**DUKE ENERGY**  
**McGUIRE NUCLEAR SITE**  
**EMERGENCY PLAN**

**REVISION 17-1: September, 2017**

DUKE ENERGY COMPANY  
McGUIRE NUCLEAR SITE  
EMERGENCY PLAN  
REVISION LIST

**FIGURE F-3  
EMERGENCY RESPONSE  
RADIO SYSTEM**

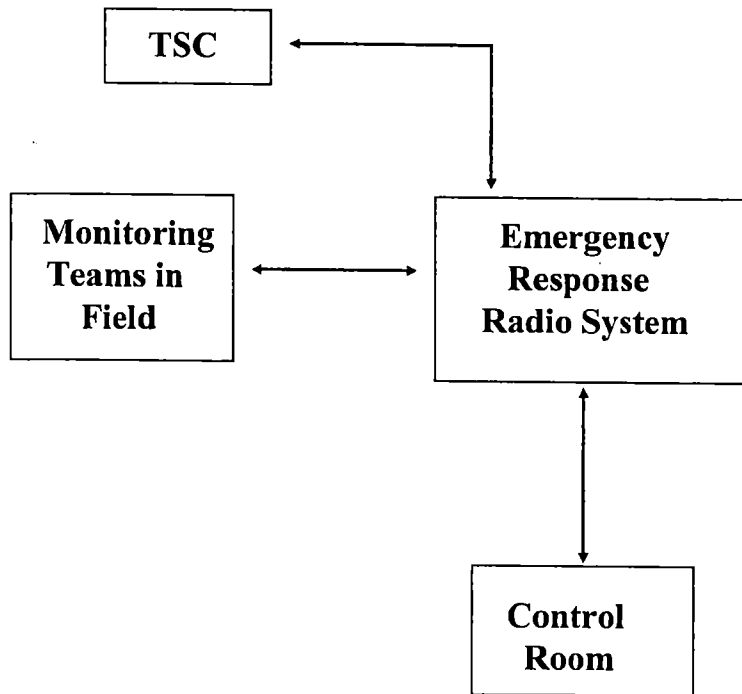
The 48.50 MHz County Emergency Response Radio is described in the McGuire Emergency Plan as a system that can be used to communicate between the Control Room, TSC, EOF and counties. This system was installed during the 1980s and is obsolete, not functional and unreliable. Due to obsolescence parts and service are not available for this equipment as it is considered antiquated technology. As a result of this change, the radio system will be removed from the McGuire Emergency Plan and physically removed from McGuire emergency facilities as well as county warning points. This equipment has already been removed from the Emergency Operations Facility.

**FIGURE F-4  
EOF COMMUNICATIONS  
DEMNET**

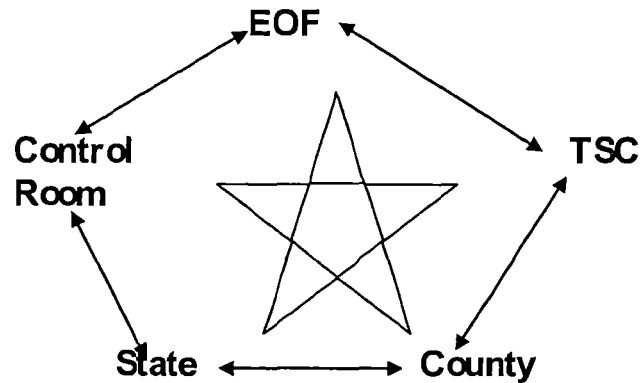
Figure F-4 depicts the various emergency communications links in areas that are manned 24-hours per day from the station to various offsite response organizations and with onsite facilities.

Figure F-4 depicts the various emergency communications links from the station to State/Local Governments.

Prior to this change the McGuire Emergency Plan described three means of contacting states/counties in the 10-mile EPZ. They are:

- DEMNET (Primary)
- Standard Telephone Lines (Backup)
- County Emergency Response Radio can be used to communicate between the Control Room, TSC, EOF and counties (48.50 MHz Radio).

As a result of this change multiple means of prompt contact with states/counties in 10-mile EPZ continue to exist including:
